ES SERVICE BULLETIN**Affected Equipment: YPAL MOD "D"
Packaged Rooftop Units w/Heat****Subject: Overheating Conditioned Space****Issue Date: 12/01/06****Withdrawal Date: 06/30/07****Data Control Level: C****Materials Needed: N/A****Tools Required: Standard Hand Tools****Est. Time Required: 1 Hour plus Travel Time****Warranty: Yes****Revision Notes: N/A****Issue:**

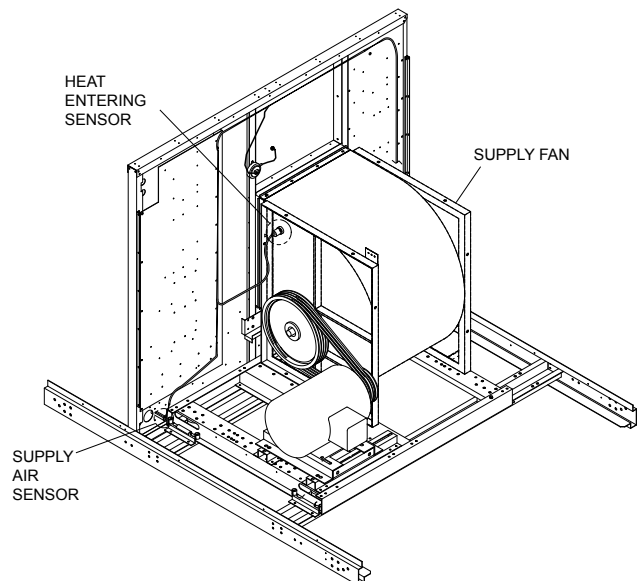
Sensor wiring was incorrectly installed at the factory. The wires that are supposed to be wired to the supply air sensor were connected to the heat entering sensor, and the wires that should be connected to the heat entering sensor were connected to the supply air sensor.

Location of these two sensors is shown at right. The heat entering sensor is located in the side scroll of the blower housing. The supply air sensor is installed in the end of the aspirator tube that runs under the heat exchanger. The supply air sensor can be found in the blower compartment in the area where the refrigerant piping goes through the wall between the blower and the supply air compartments.

- Remove wires 308 and 309 from the heat entering sensor.
- Remove wires 310 and 311 from the supply air sensor.
- Connect wires 308 and 309 to the supply air sensor and wires 310 and 311 to the heat entering sensor.
